DATE 7-7-53  
 SH. 1 OF 1  
 COMPILED BY  
 G.T.O.

TMC SPECIFICATION NO. S-170 A

TITLE: Changes Necessary for Remote Control of RF Gain and AVC on-off --- FFR Receiver. JOB

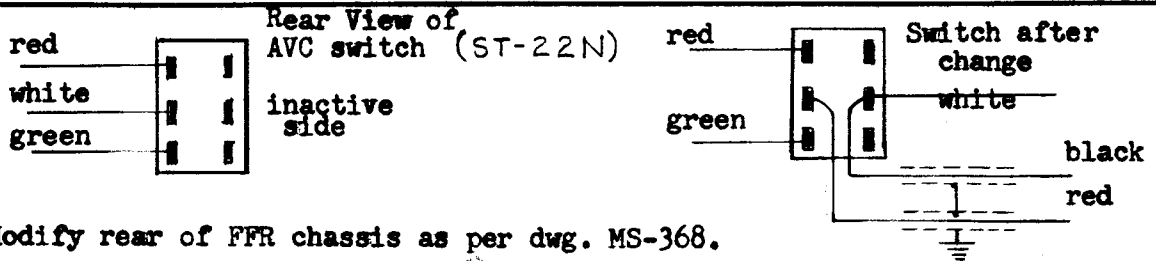
1. Modify rear of FFR chassis as per dwg. MS-368.
2. Cut 18" of 1/c shield wire (WI-101-1 black) and 18" of 1/c shield wire (WI-116-1 red).
3. Remove white lead from AVC switch arm and connect to arm of inactive side as shown above.
4. Connect red and black shielded wire leads to switch as shown.
5. Connect both shield braids to ground lugs which is located below switch.
6. Insert the two shielded wires adjacent to the large cable harness, in the existing cable clamps.

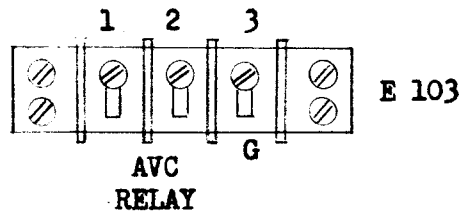
7. Connect the opposite ends of the shielded wires as shown above and stamp the terminal strip as shown below; ie - 1 2 3 - AVC RELAY- G- E 103.

**NOTE:** When this modified receiver is not used in a RCR System, then terminals 1 and 2 on board E 103 must be jumped together externally. Ref; CK-185
